Draft Final Decision Document
for the Interim Response Action
for the Improvement of the North Boundary System
at Rocky Mountain Arsenal
Via Construction of Groundwater Recharge Trenches

June, 1988

RESPONSE TO US EPA REVIEW COMMENTS
ON PROPOSED DECISION DOCUMENT FOR
THE INTERIM RESPONSE ACTION FOR THE
IMPROVEMENT OF THE NORTH BOUNDARY SYSTEM
AT ROCKY MOUNTAIN ARSENAL VIA CONSTRUCTION
OF GROUNDWATER RECHARGE TRENCHES

RESPONSE TO STATE OF COLORADO REVIEW
COMMENTS ON PROPOSED DECISION DOCUMENT FOR
THE INTERIM RESPONSE ACTION FOR THE
IMPROVEMENT OF THE NORTH BOUNDARY SYSTEM
AT ROCKY MOUNTAIN ARSENAL VIA CONSTRUCTION
OF GROUNDWATER RECHARGE TRENCHES

Figure 3. Generalized Alluvial Groundwater Flow Across RMA

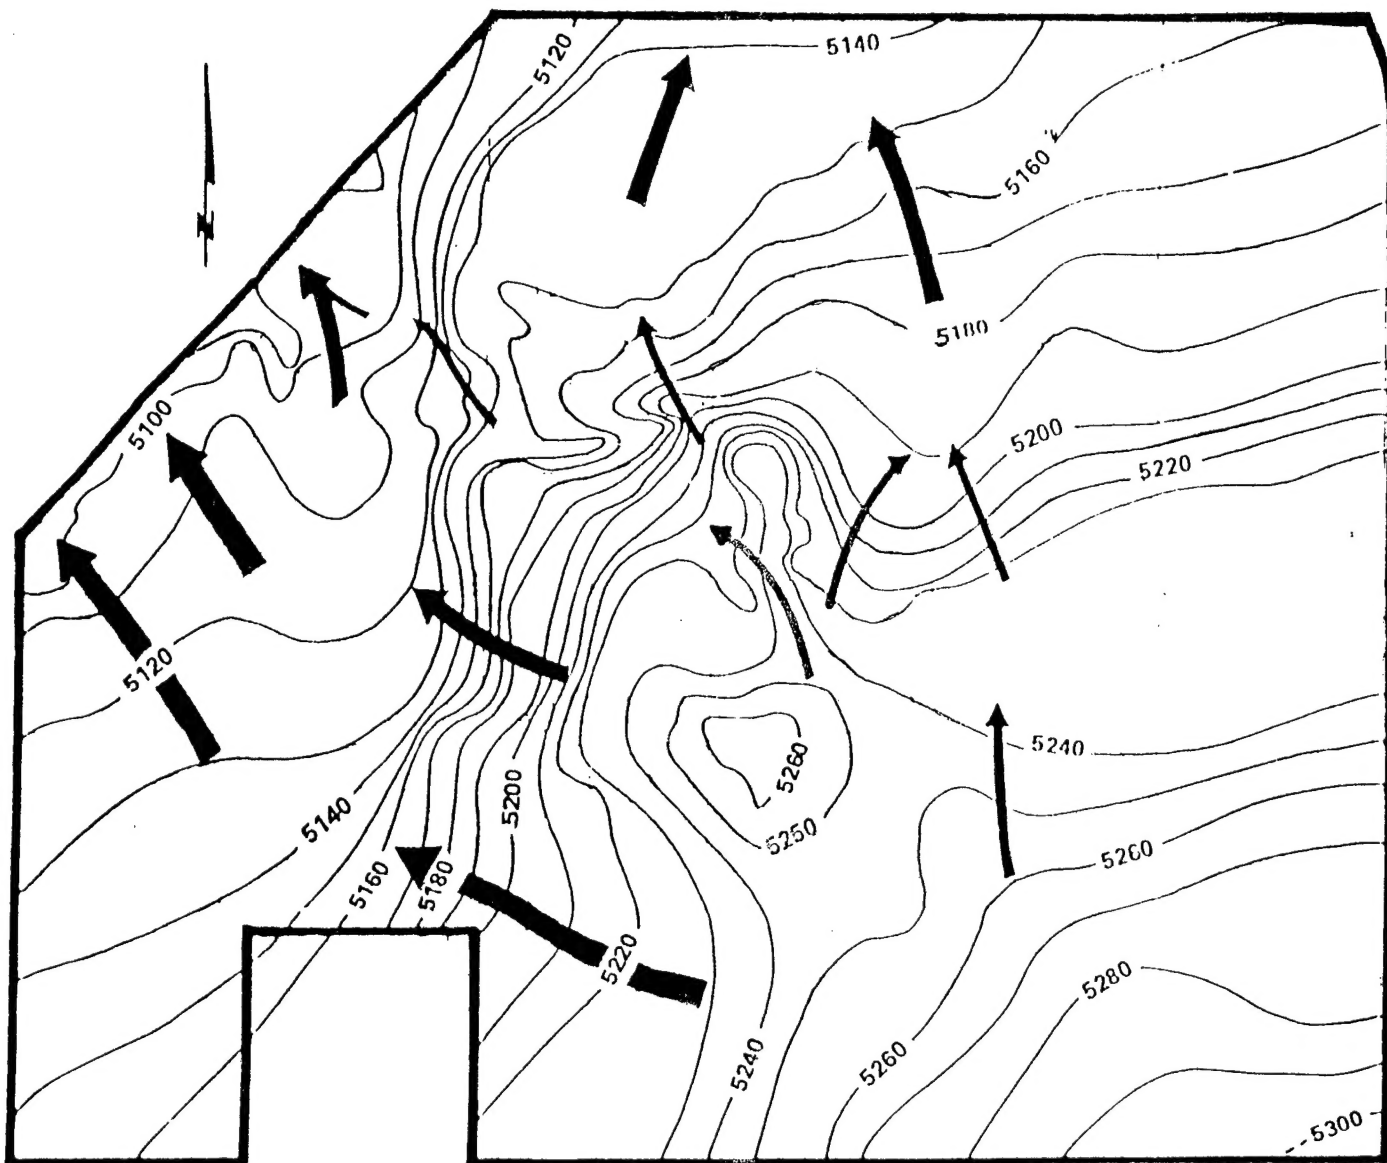
3. Pg. 2, para. 3. The second sentence should indicate that, generally alluvial groundwater beneath RMA flows from southeast to northwest and that Figure 3 represents generalized alluvial groundwater flow across RMA. Emphasis added.

4. Pg. 5, Figure 3. See Specific Comment ³8.

3. Page 2, paragraph 3. Emphasize text to clarify generality.

4. Page 5, paragraph 3. See specific comment 3.

Response: The text shall be modified as follows: "Alluvial groundwater beneath RMA generally flows from southeast to the northwest. Figure 3 represents the generalized alluvial groundwater flow across RMA."

Response: The description for Figure 3 shall be modified as follows: "Generalized Alluvial Groundwater Flow Across RMA."
